RHODE ISLAND DEPARTMENT OF TRANSPORTATION

I-195 Relocation – Contract 16 – Providence River Pedestrian Bridge

NOTICE TO PROSPECTIVE BIDDERS

ADDENDUM NO. 9 Prospective bidders and all concerned are hereby notified of the following changes in the Plans, Specifications, Proposal and Distribution of Quantities for this contract. These changes shall be incorporated in the Plans, Specifications, Proposal and Distribution of Quantities, and shall become an integral part of the Contract Documents.

ENLARGED LOWER BRIDGE LIGHTING PLAN E205

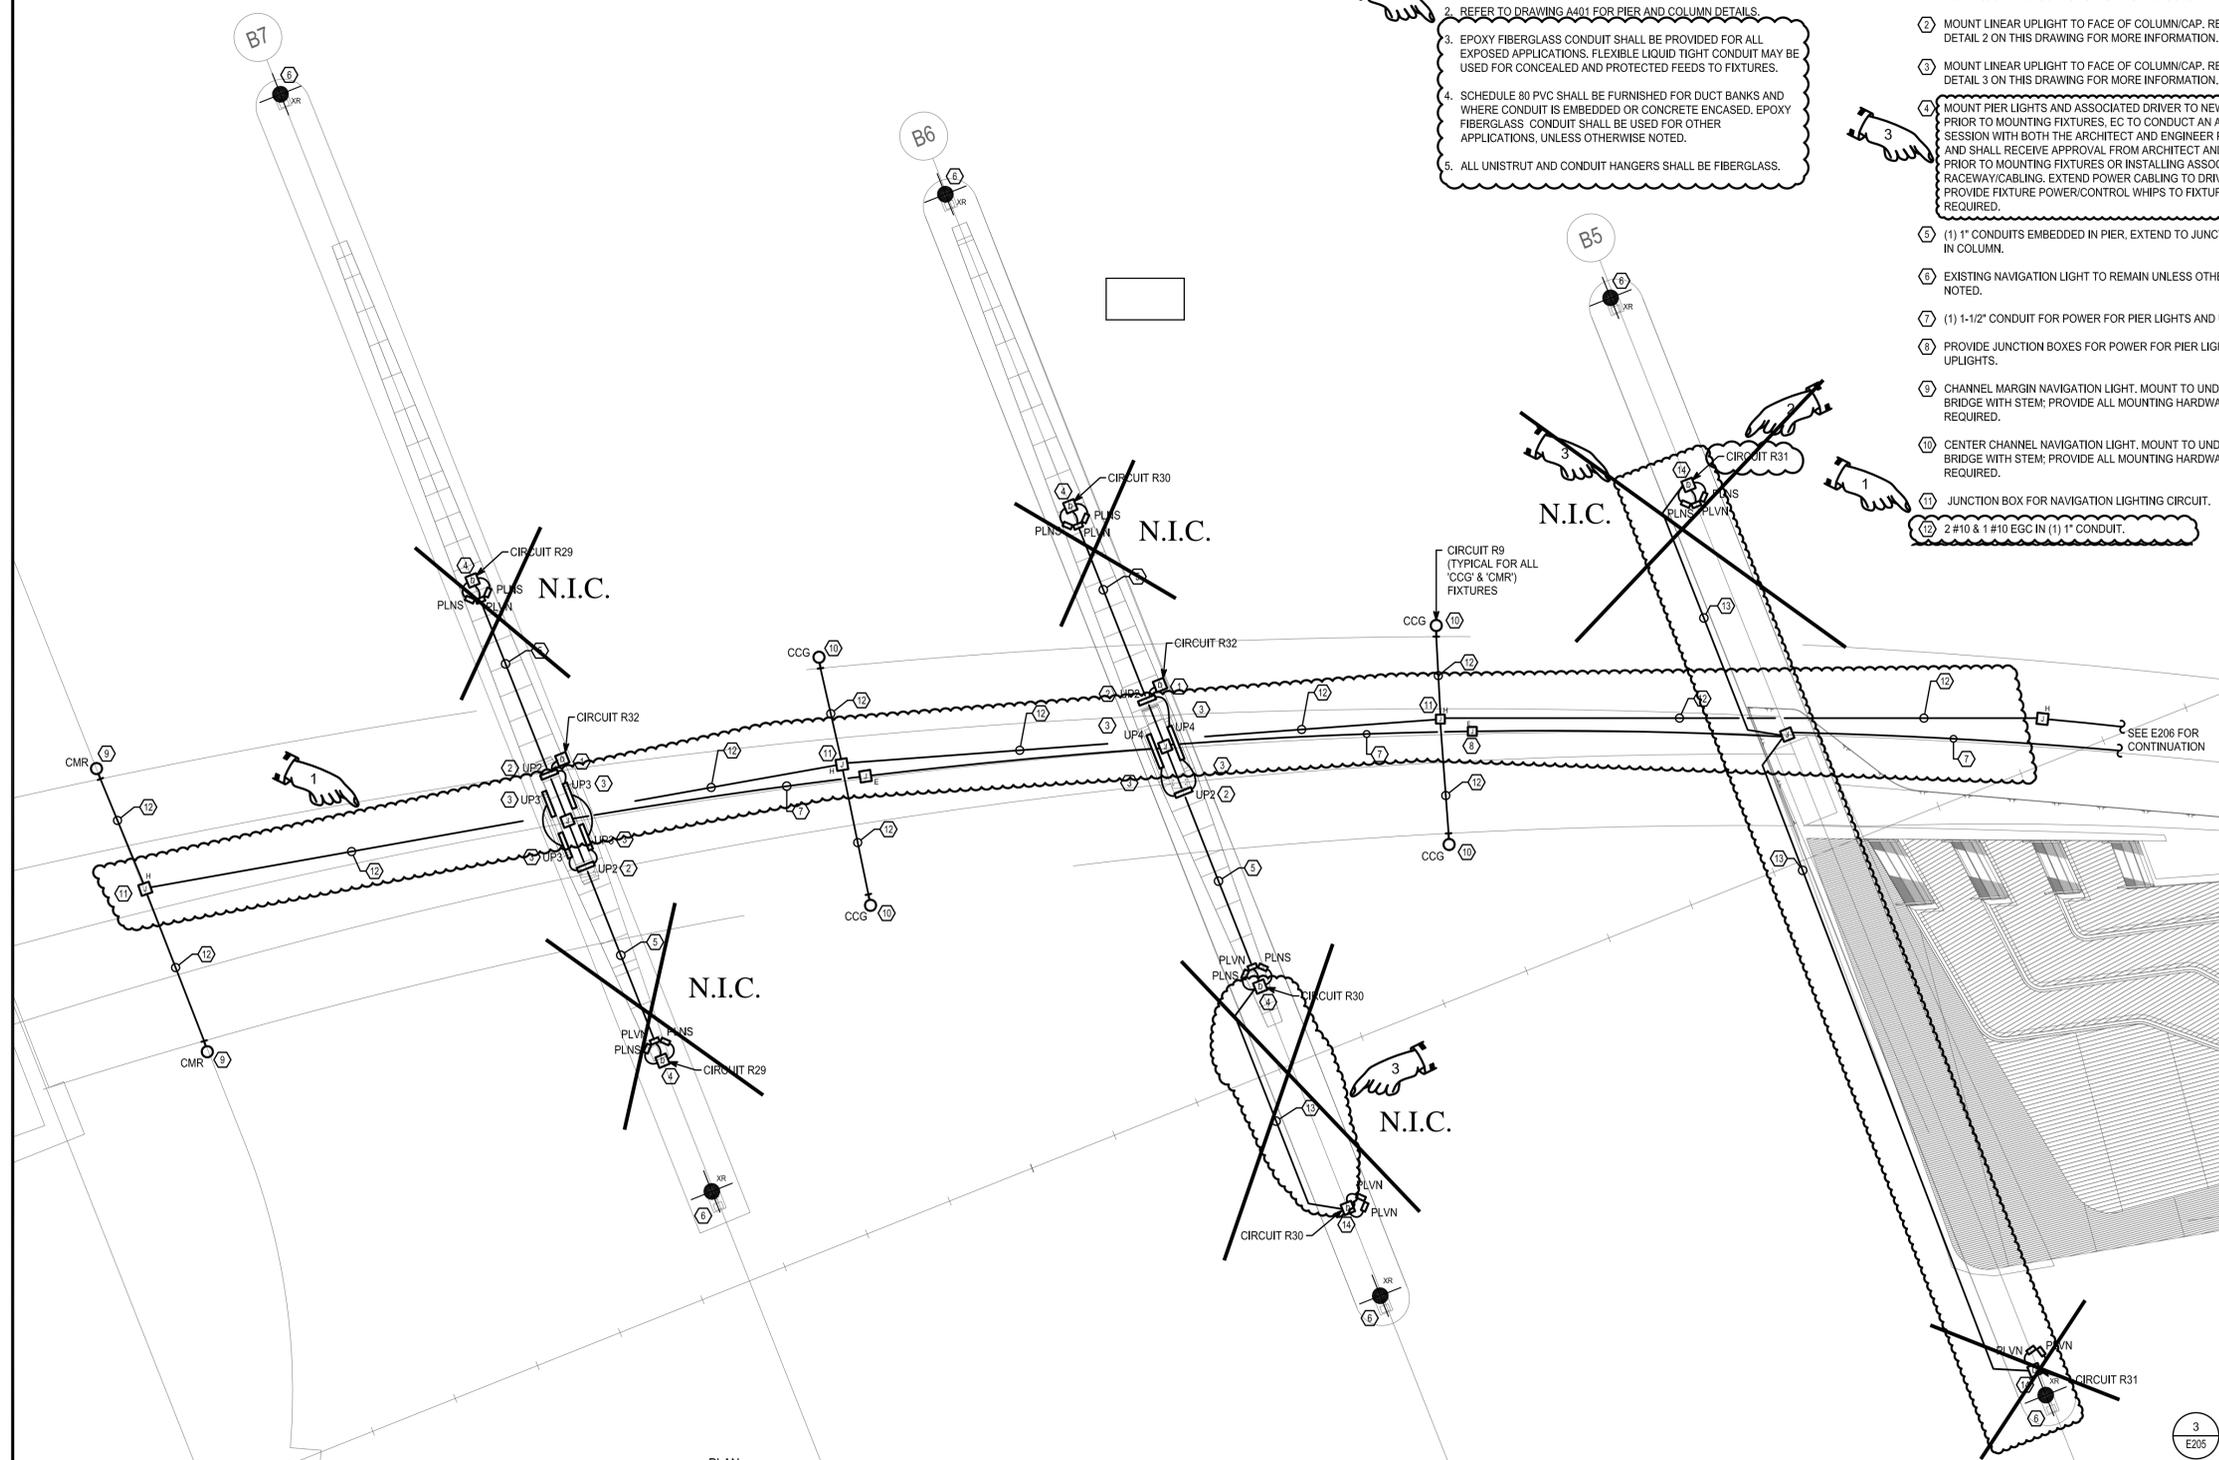
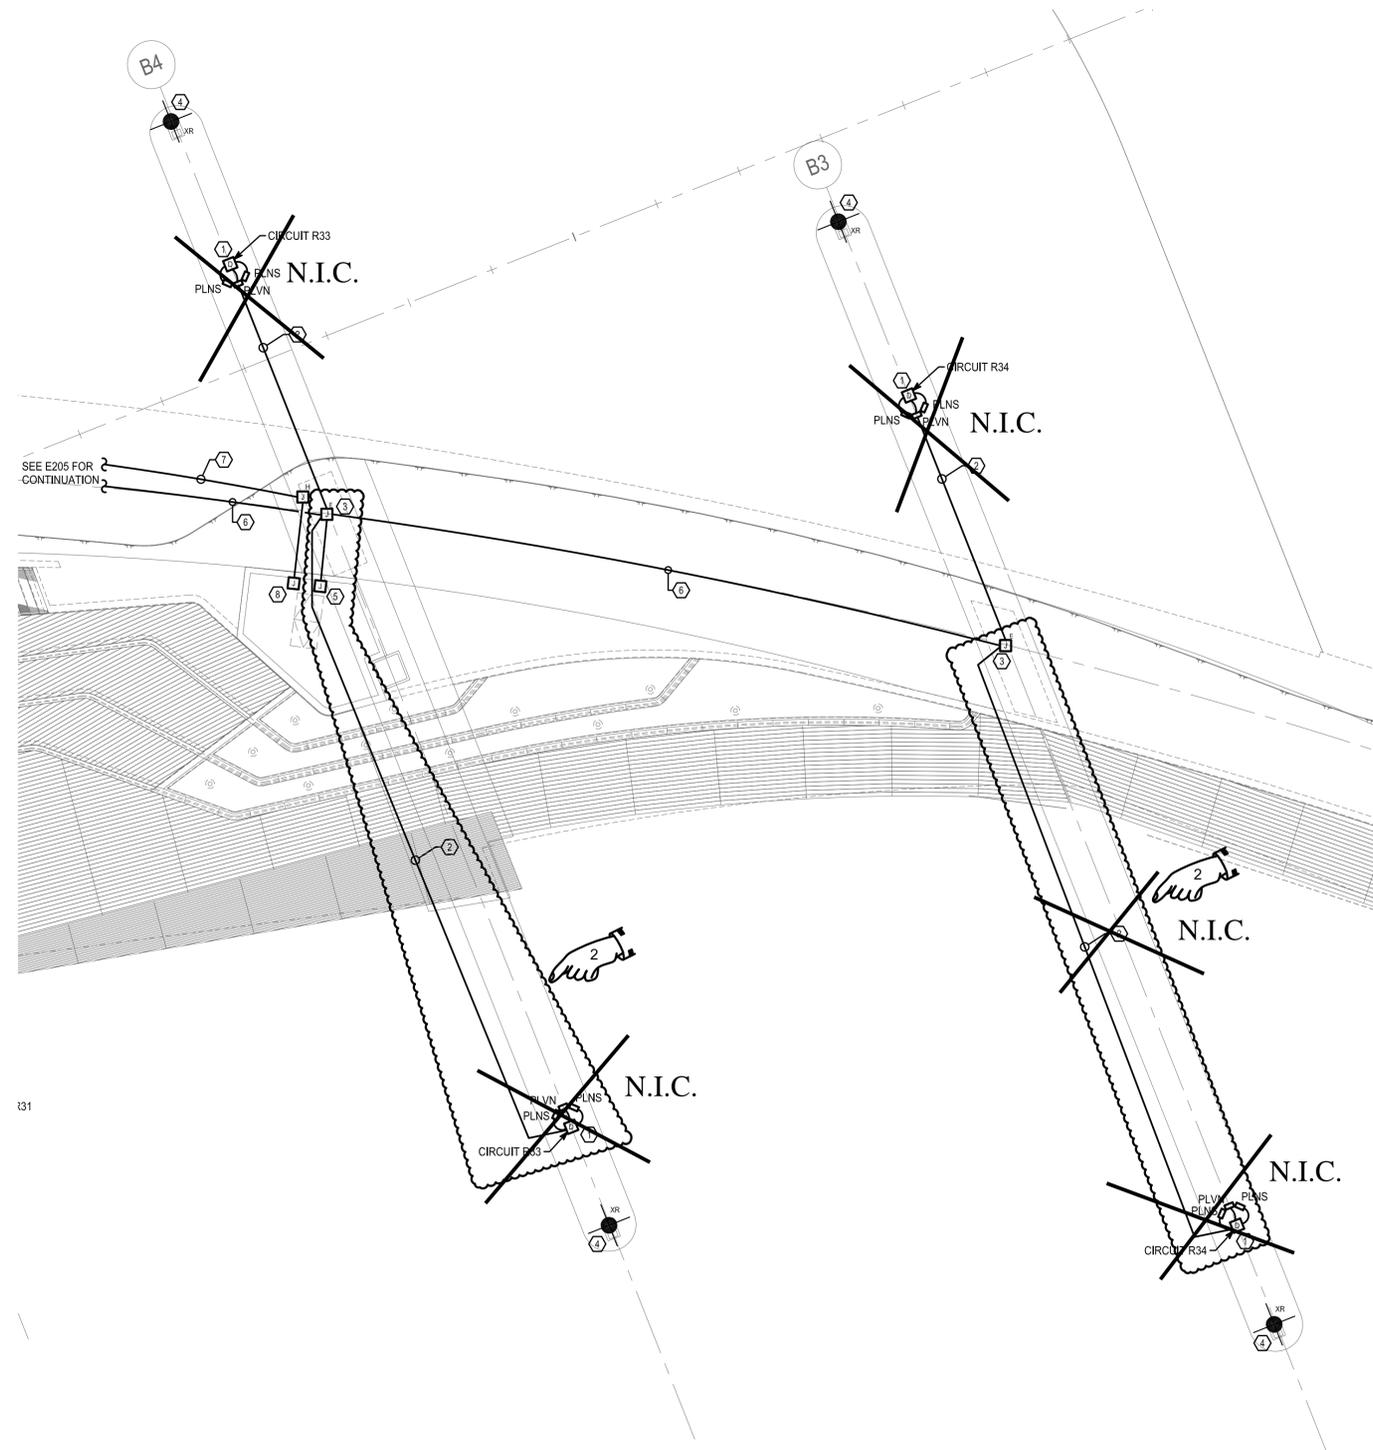
37. Sheet V2_154(R-2)
Delete Sheet V2_154(R-2) in its entirety and replace it with sheet V2_154(R-3) attached to this Addendum No. 9. Lighting fixtures PLVN and PLNS and associated conduit have been removed from the Contract. Pier lighting notes have been revised.
